SERVICE NEWS

AIRCOOLED MOTORS INC.

No. FSN 4

**SUBJECT: FRANKLIN AIRCRAFT ENGINE CYLINDER RECONDITIONING MODELS
6A4-150, 6A4-165, 6V4-178 AND 6A8-215**

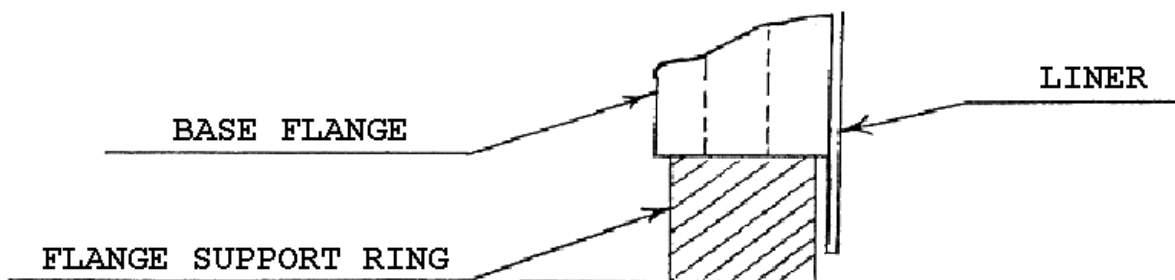
We have received reports to the effect that cylinders covering the above model engines are not being properly supported in some cases when valve guides are installed in the field as replacement due to removal of worn guides.

When valve guides are installed, after heating the cylinder in accordance with instructions in the Service Manuals, the cylinders should be supported on the base flange section and not on the cast iron cylinder liner.

Supporting the cylinder base flange on a steel ring thick enough to prevent the liner from taking any load will prevent the liner from moving up into the cylinder. See Sketch Below.
